[Docket No. FAA-2023-0672; Project Identifier AD-2022-01429-T; Amendment 39-22470; AD 2023-12-12]

Airworthiness Directives; The Boeing Company Airplanes

ACTION: Final rule.

Figure 1 to paragraph (g)(2)(i)—*Fundamental Effective Isotropic PSD at Outside Interface of Aircraft Antenna*

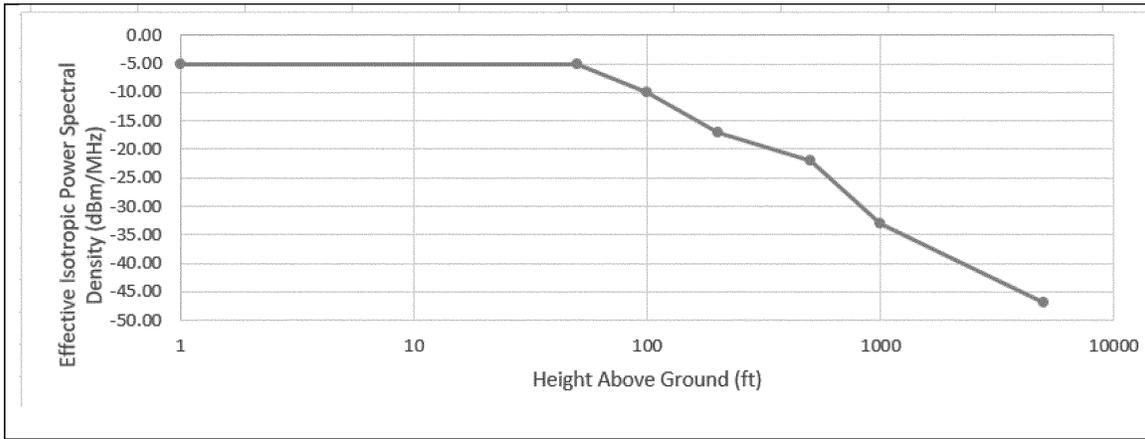
(i) Tolerance to radio altimeter interference, for the fundamental emissions (3.7–3.98 GHz), at or above the power spectral density (PSD) curve threshold specified in figure 1 to paragraph (g)(2)(i) of this AD.

Figure 2 to paragraph (g)(2)(ii)—*Spurious Effective Isotropic PSD at Outside Interface of Aircraft Antenna*

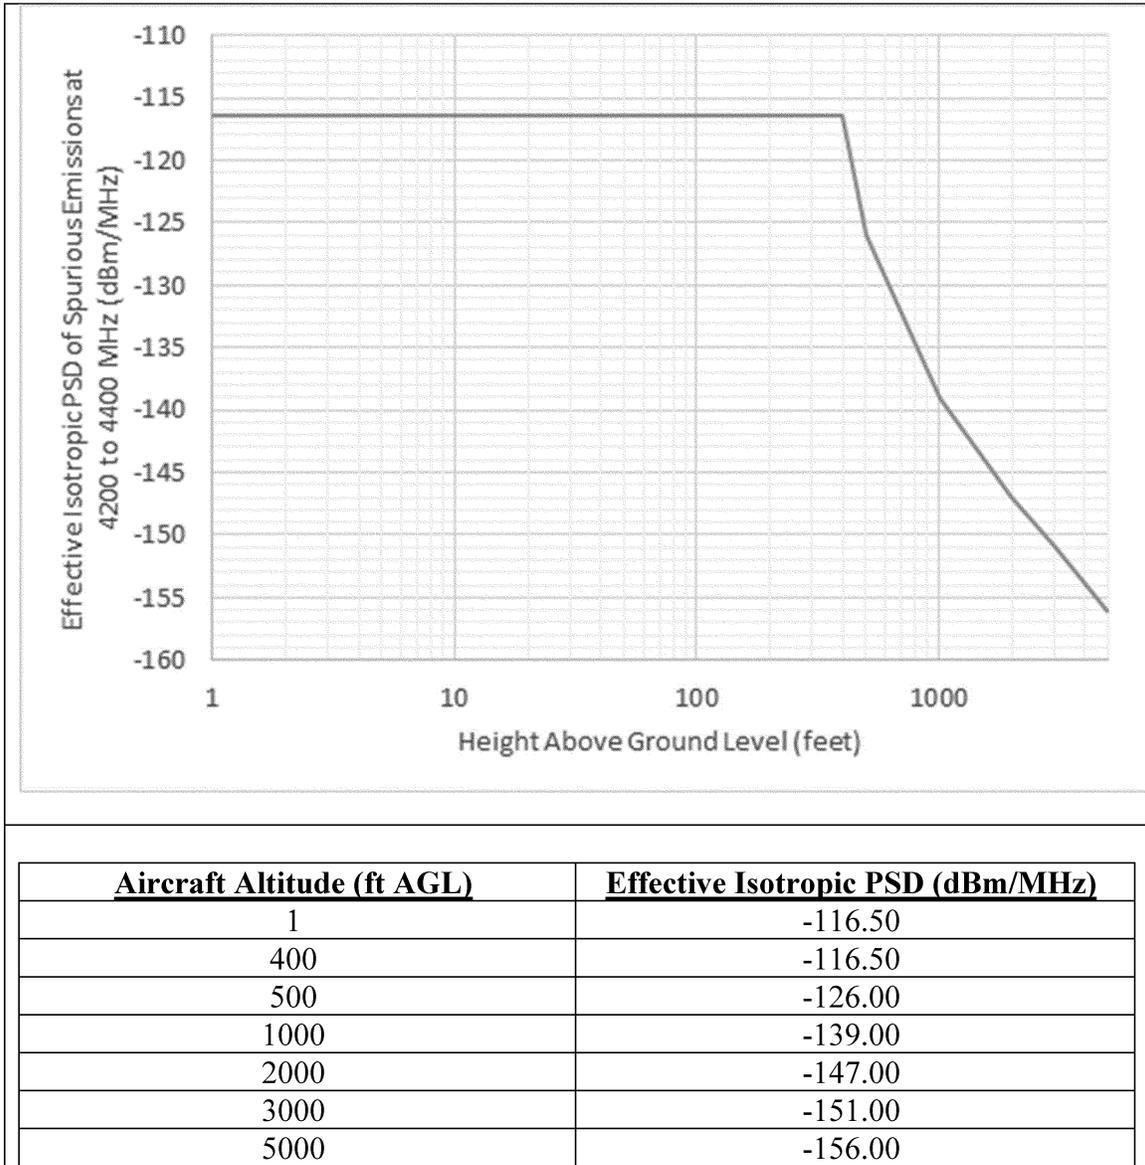
(ii) Tolerance to radio altimeter interference, for the spurious emissions (3.7–

3.98 GHz), at or above the PSD curve

threshold specified in figure 2 to paragraph (g)(2)(ii) of this AD.
